ADDENDUM NO. 1

COUNTY OF ERIE  
DEPARTMENT OF ENVIRONMENT AND PLANNING  
ERIE COUNTY SEWER DISTRICT NO. 4  
CONTRACT NO. 61  
DEPEW PUMPING STATION IMPROVEMENTS

**ADDENDUM No. 1**

Sheet No. **ED-101**

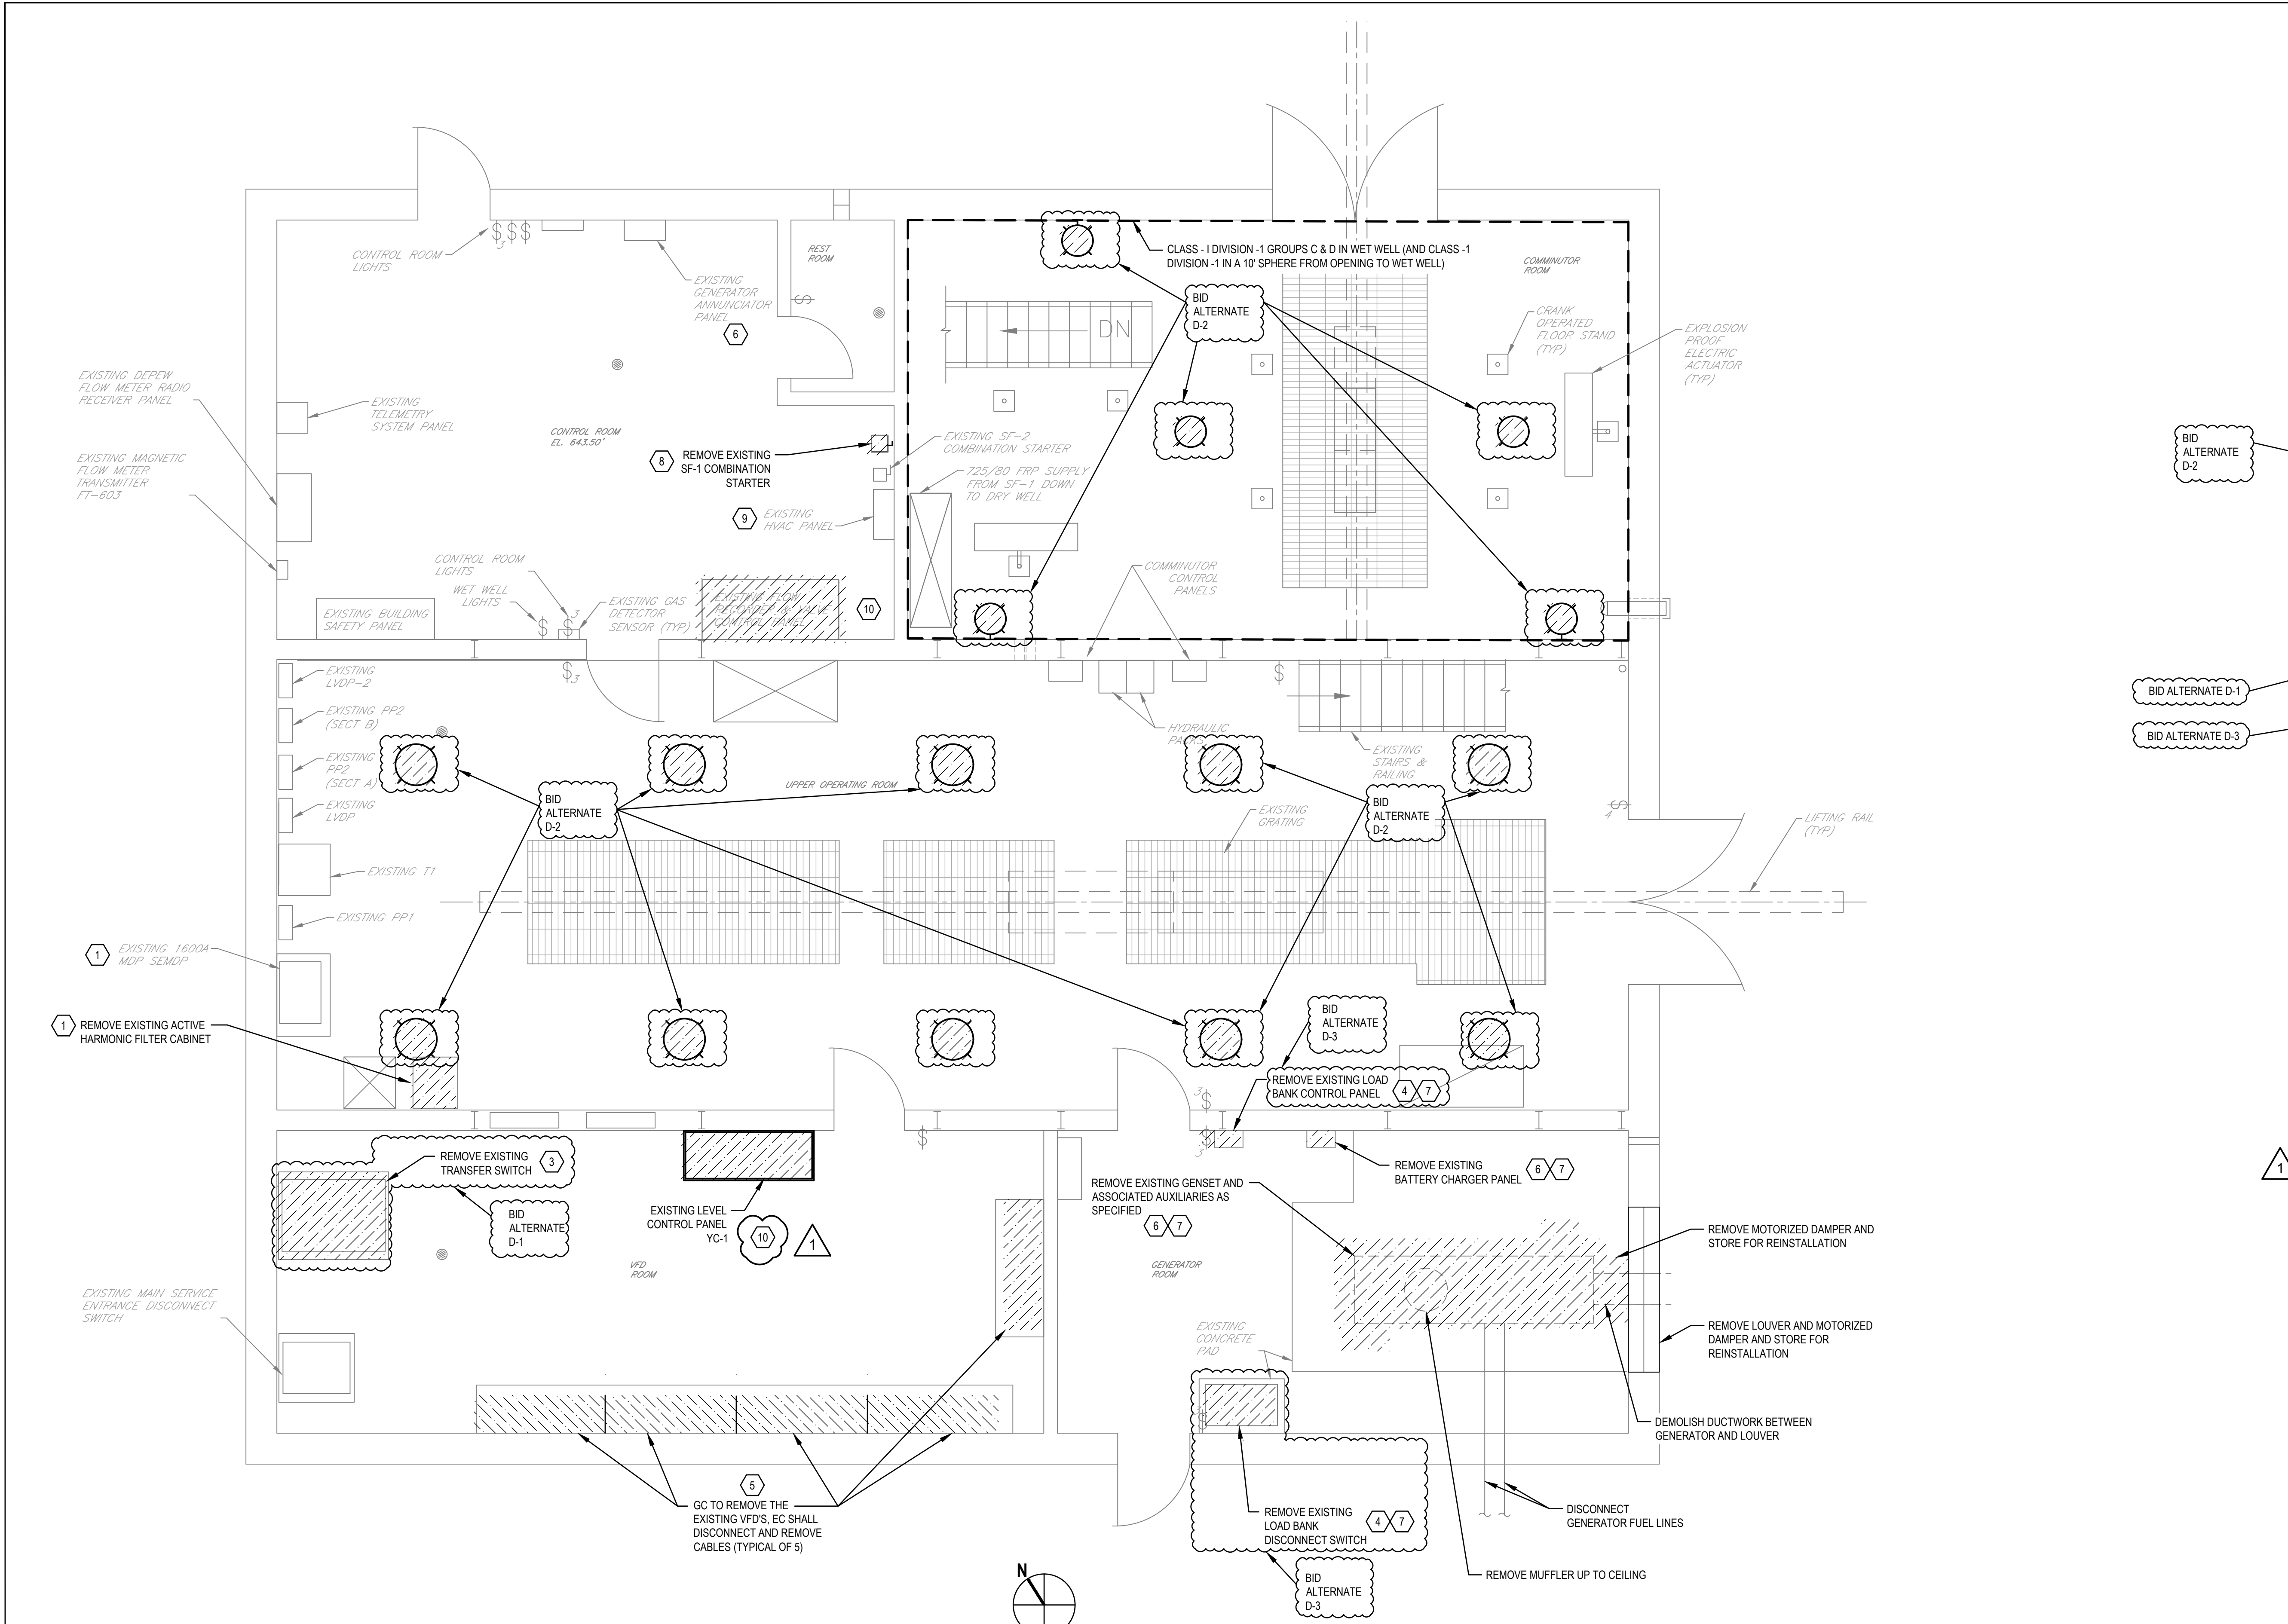
1. **Existing Pump Station Upper Level Electrical Demolition Plan Drawing No. ED-101 – Delete Drawing in its entirety and Replace with Attachment 2.**
